Roadway Plans_V1.pdf Markup Summary

CLEARWAY FILING NO. 2, LOT 5		TITLE SHEET	
PROJECT NO. 44-042A		DATE: 06-02-2022	
DESIGNED BY: DLM		SCALE: HORIZONTAL: N/A	
DRAWN BY: CLP		VERTICAL: N/A	
CHECKED BY: DLM		SHEET 1 OF 15	
212 N WAHSATCH AVE, STE 305 COLORADO SPRINGS, CO 80903 PHONE: 719.955.5485		TS01	
FOR AND ON BEHALF OF M&S CIVIL CONSULTANTS, INC.			
VIRGIL A. SANCHEZ, COLORADO P.E. NO. 37160			
REVISIONS:			
NO.	DATE	BY	DESCRIPTION
THE ENGINEER PREPARING THESE PLANS WILL NOT BE RESPONSIBLE, OR LIABLE FOR, UNAUTHORIZED CHANGES TO OR USES OF THESE PLANS. ALL CHANGES TO THE PLANS MUST BE IN WRITING AND MUST BE APPROVED BY THE PREPARE OF THESE PLANS.			
CAUTION

STORM SEWER PLAN AND PROFILE

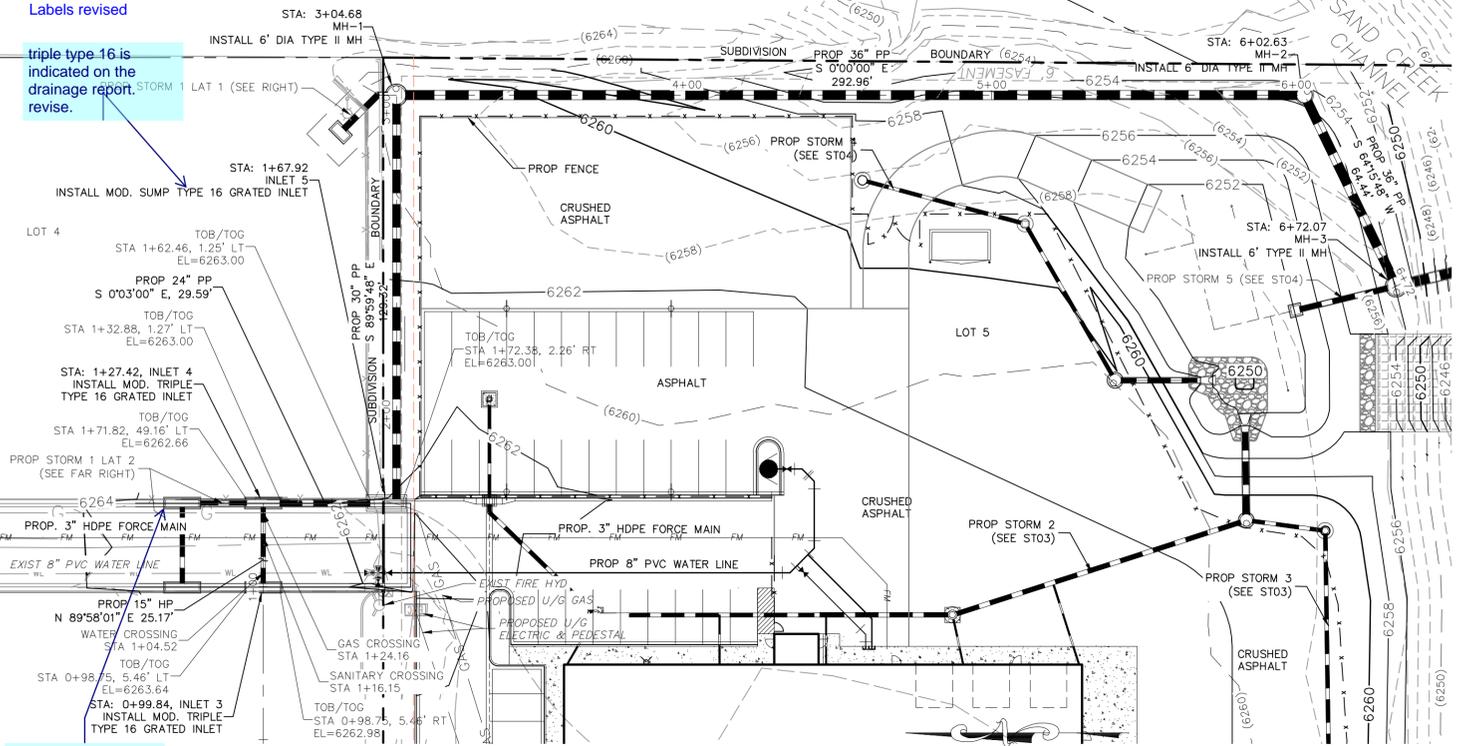
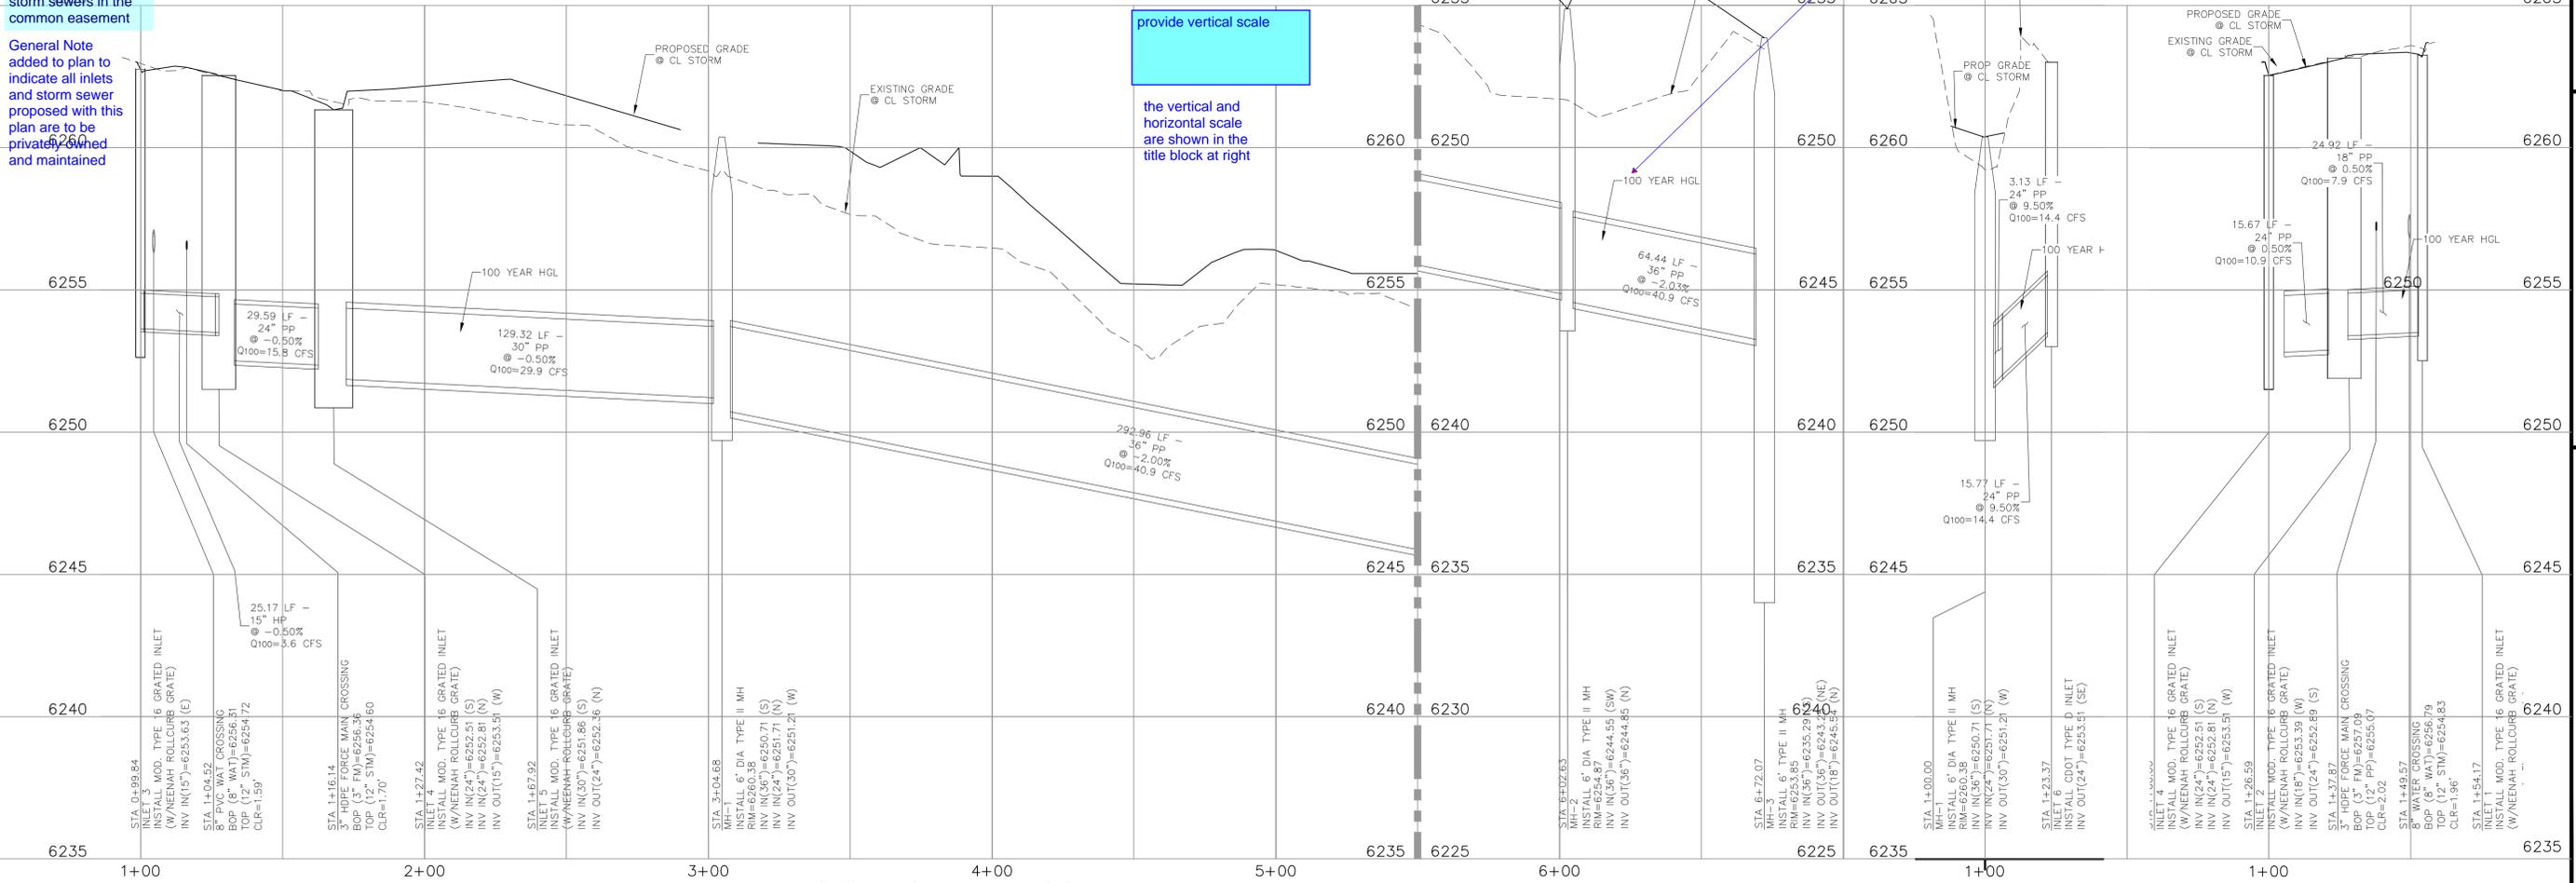
Labels revised
 triple type 16 is indicated on the drainage report revise.

identify who will maintain the proposed inlets and storm sewers in the common easement

provide vertical scale

Show HGL lines on the profiles. Typical at all storm profiles.

General Note added to plan to indicate all inlets and storm sewer proposed with this plan are to be privately owned and maintained

HGL lines added to plans

STORM SEWER PLAN AND PROFILE

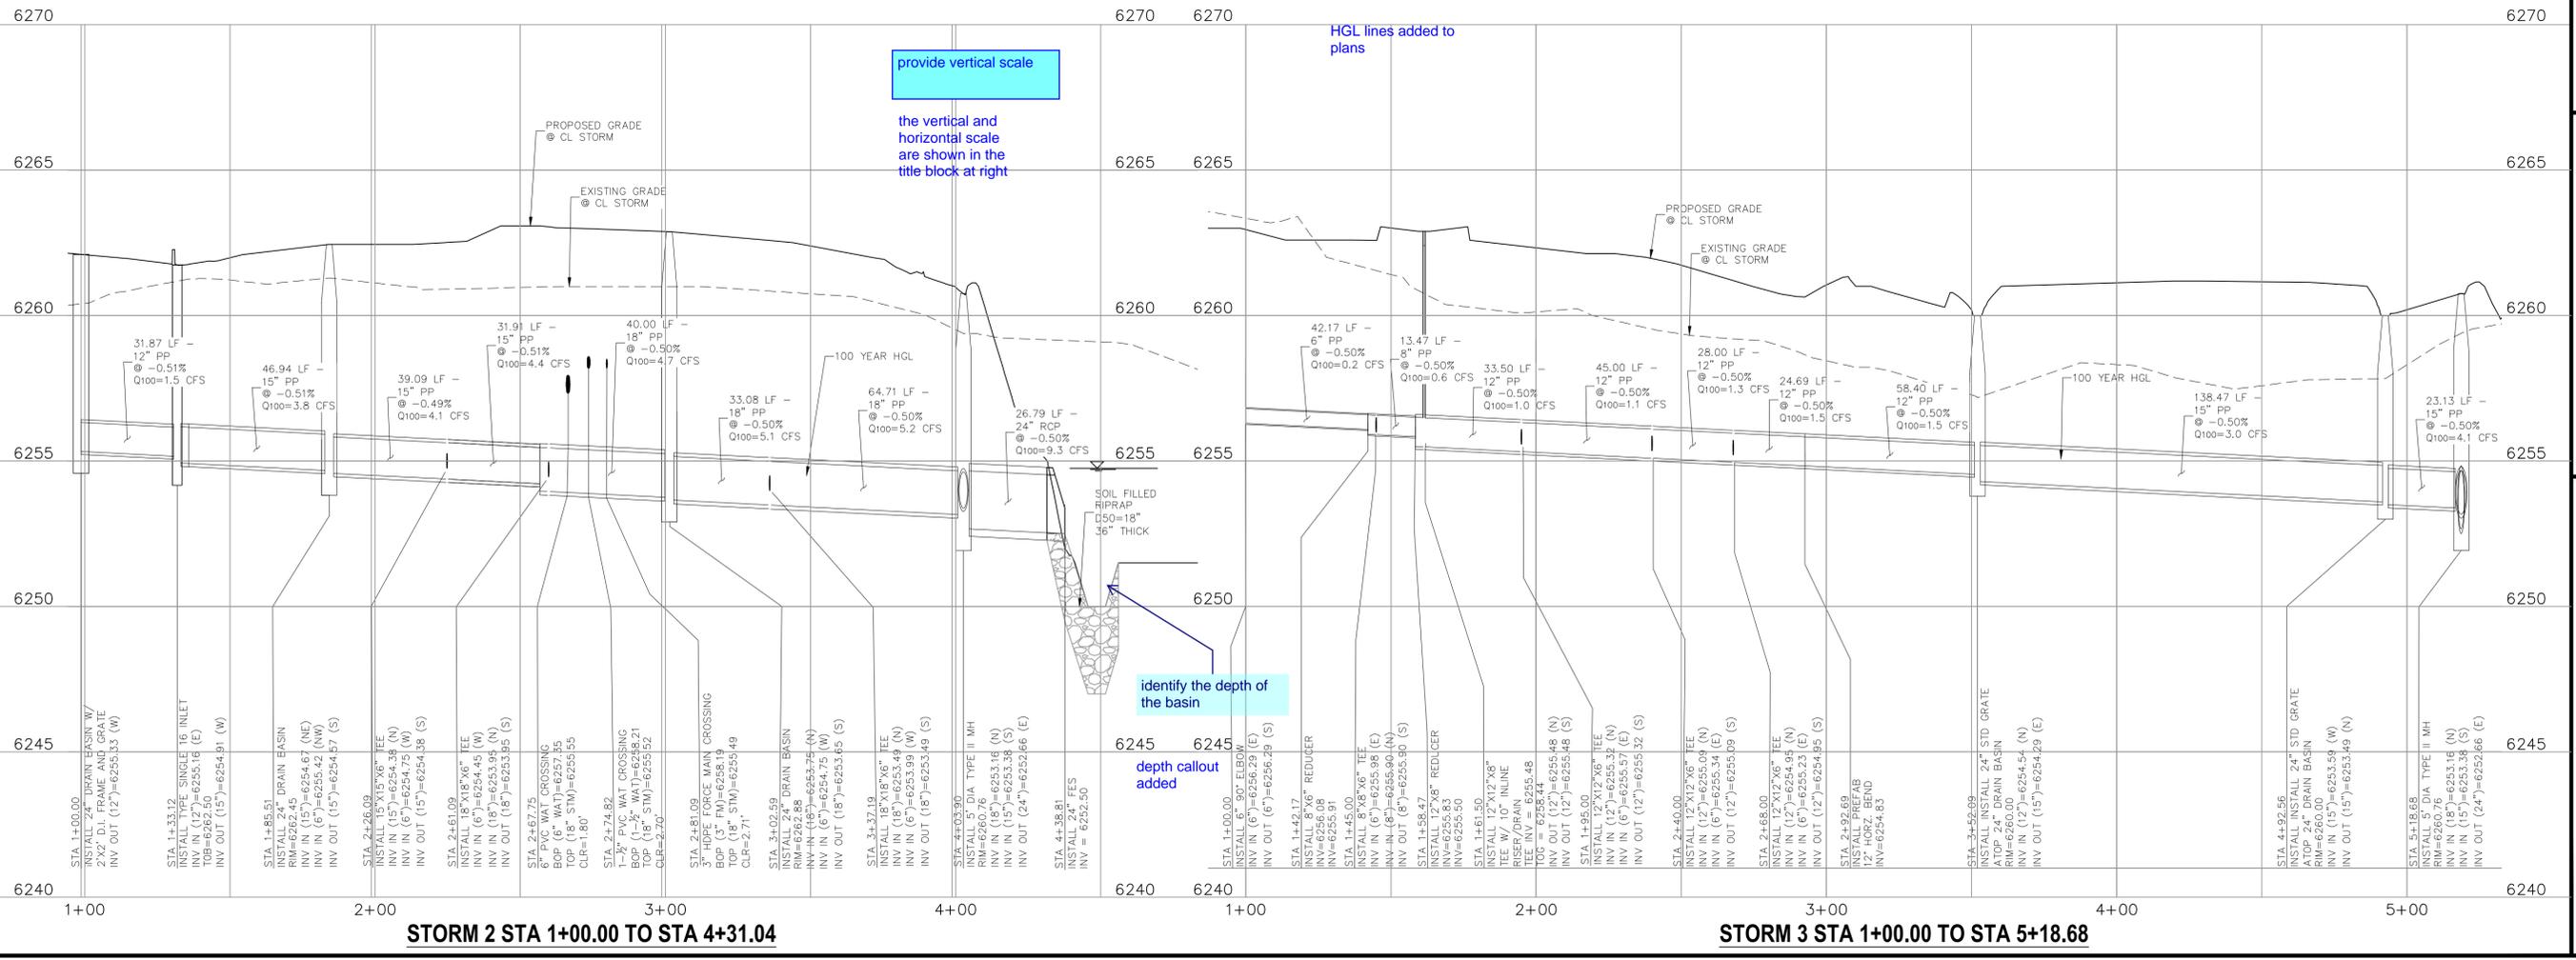
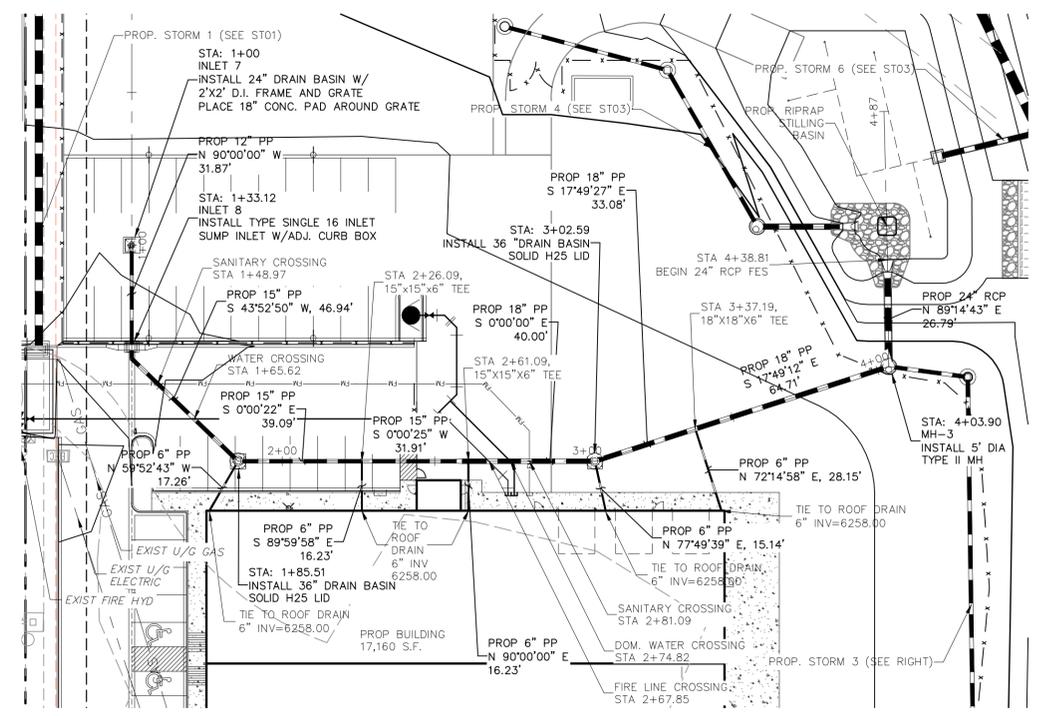
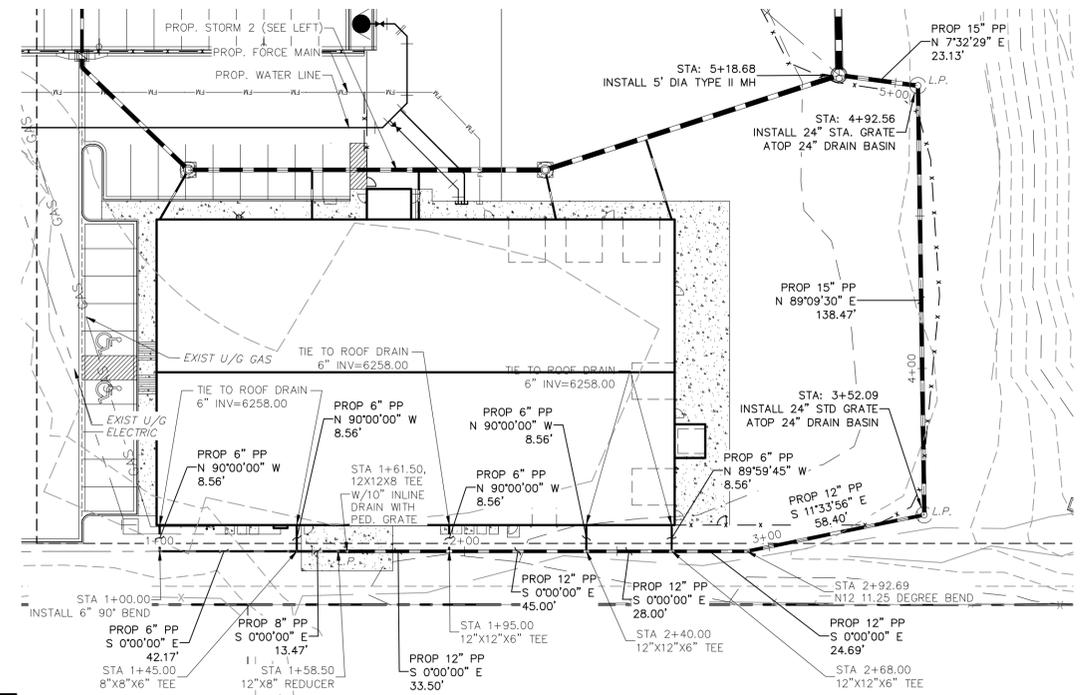
Show HGL lines on the profiles.

provide vertical scale
the vertical and horizontal scale are shown in the title block at right

identify the depth of the basin
depth callout added

**STORM 5
 STA 1+00.00 TO STA 1+46.03**

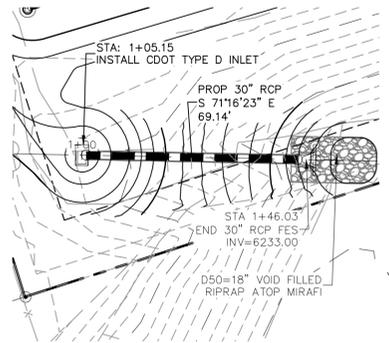
18" identified on the drainage plan. Revise accordingly.
 line sized revised to match drainage report

**STORM 6
 STA 1+00.00 TO STA 1+61.31**

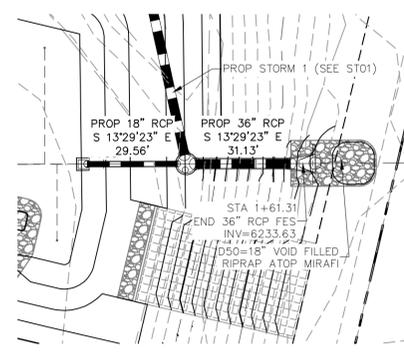
Show HGL lines on the profiles.

HGL lines added to plans

CLEARWAY FILING NO. 2, LOT 5	
STORM SEWER PLAN AND PROFILE	
PROJECT NO. 44-042A	DATE: 06-02-2022
DESIGNED BY: DLM	SCALE: HORIZONTAL: 1"=30'
DRAWN BY: CLP	VERTICAL: 1"=3'
CHECKED BY: DLM	
SHEET 8 OF 15	
ST03

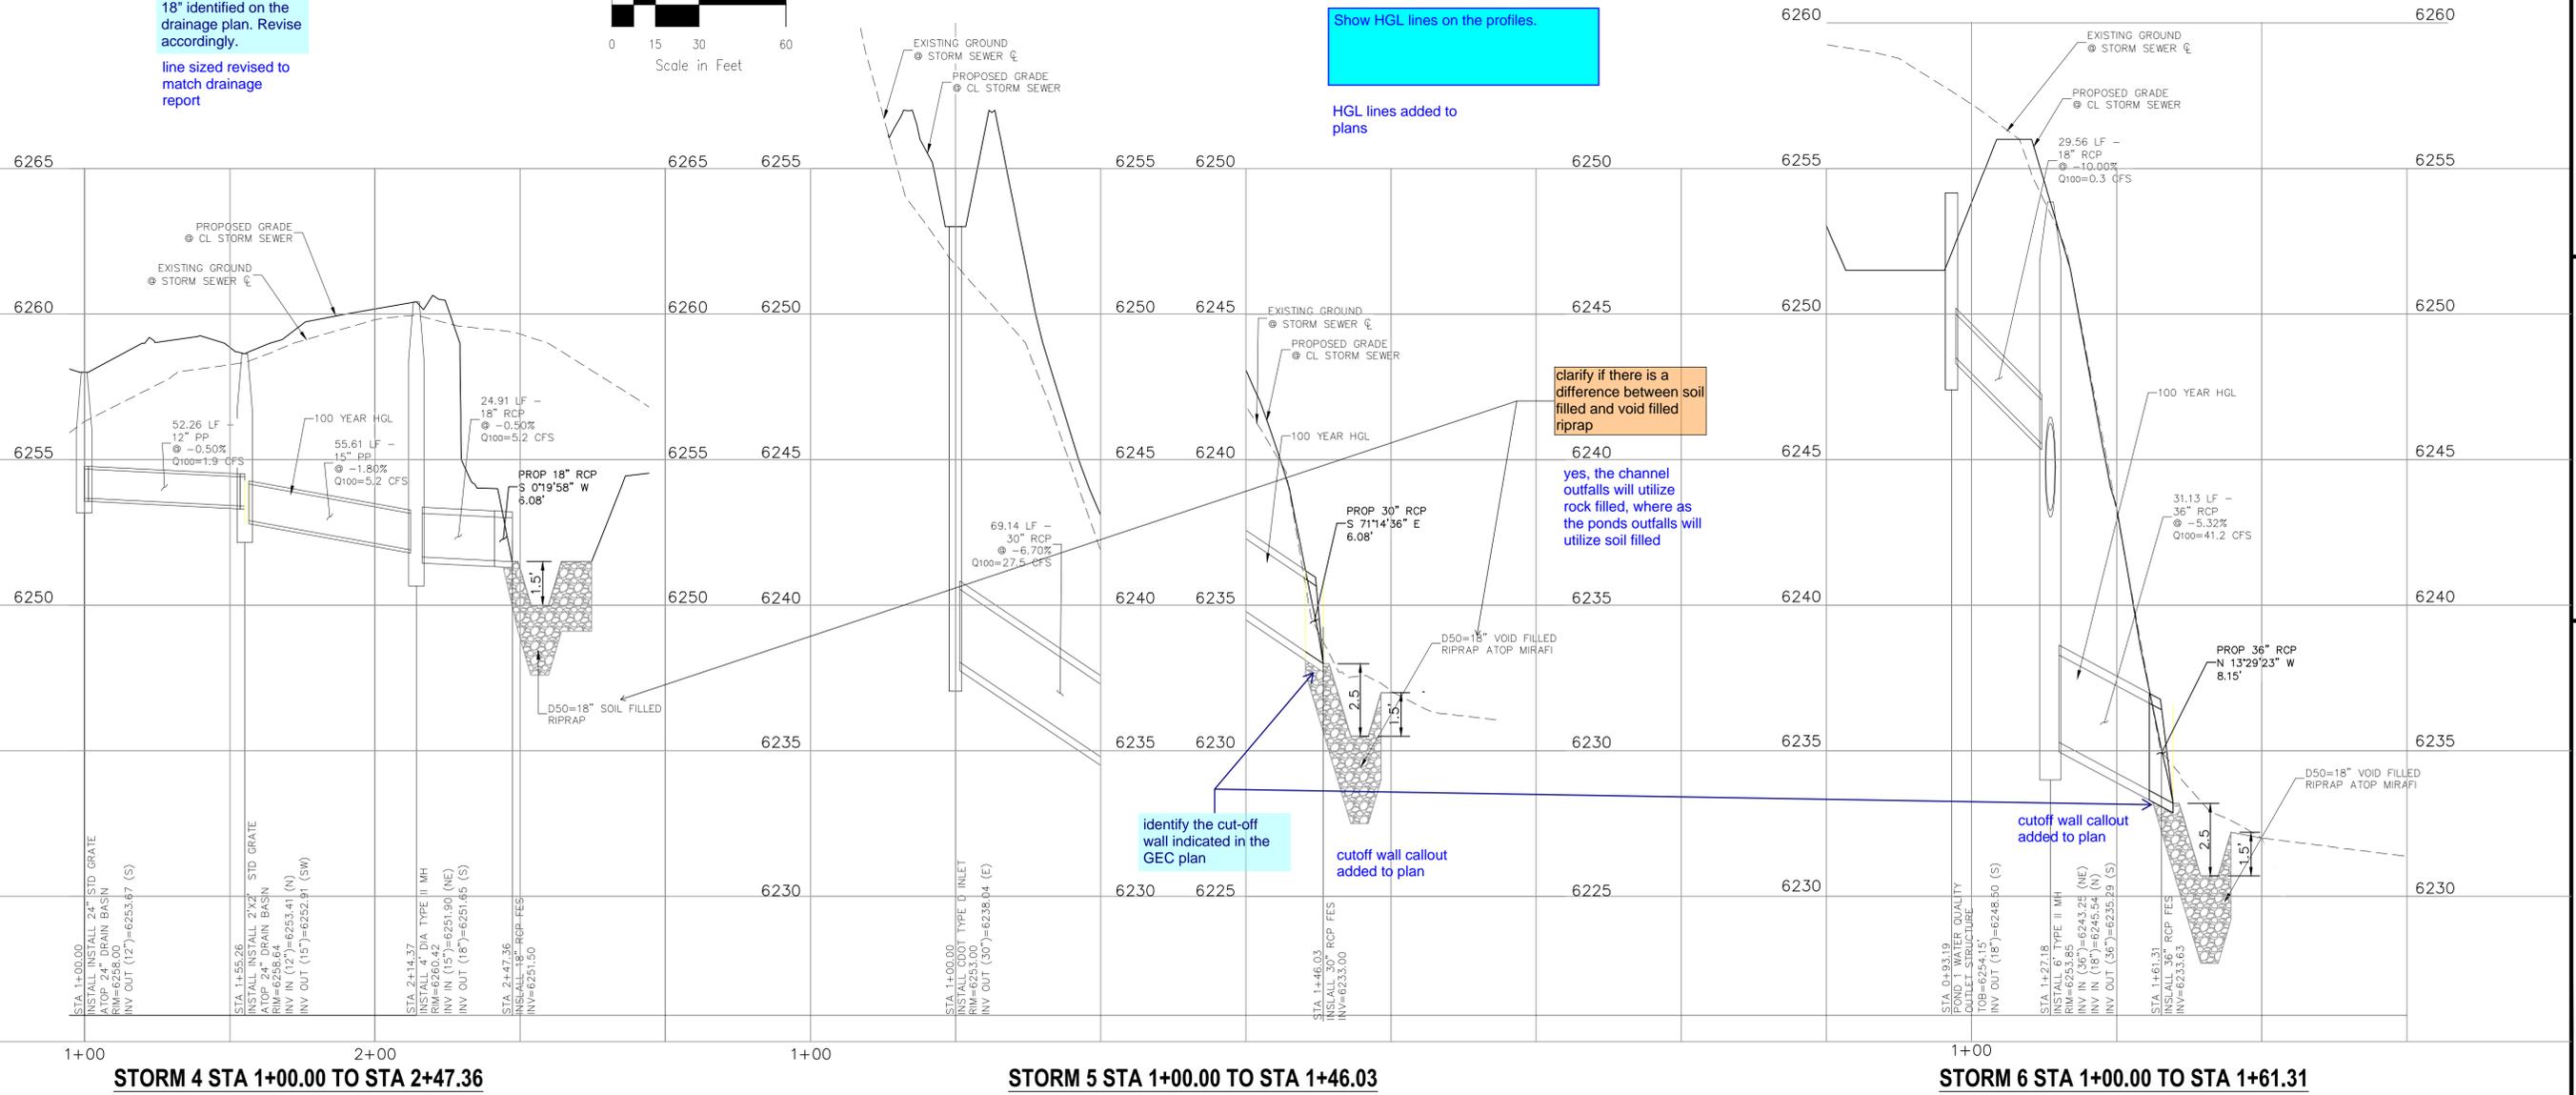
clarify if there is a difference between soil filled and void filled riprap
 yes, the channel outfalls will utilize rock filled, where as the ponds outfalls will utilize soil filled

identify the cut-off wall indicated in the GEC plan

cutoff wall callout added to plan

CLEARWAY FILING NO. 2, LOT 5		DATE: 06-02-2022	
STORM SEWER NOTES AND DETAILS		HORIZONTAL: N/A	VERTICAL: N/A
PROJECT NO. 44-042A	DESIGNED BY: DLM	CHECKED BY: DLM	SHEET 9 OF 15
	DRAWN BY: CLP		ST04

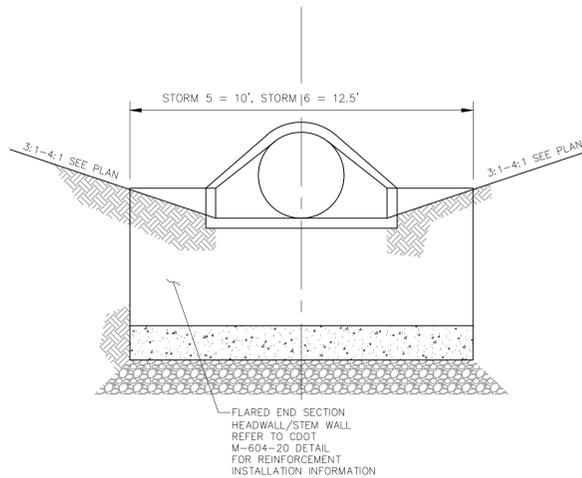
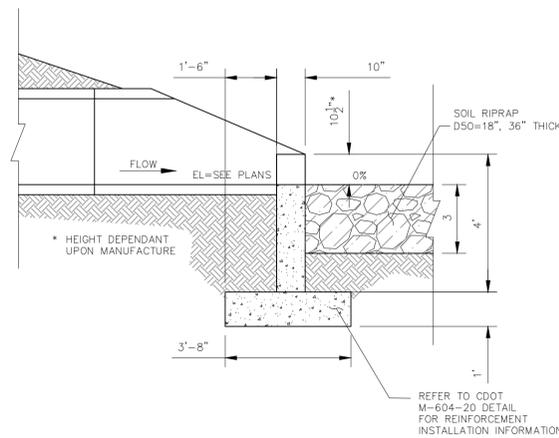
suggest adding U.N.O. as not all pipes indicated are RCP note revised
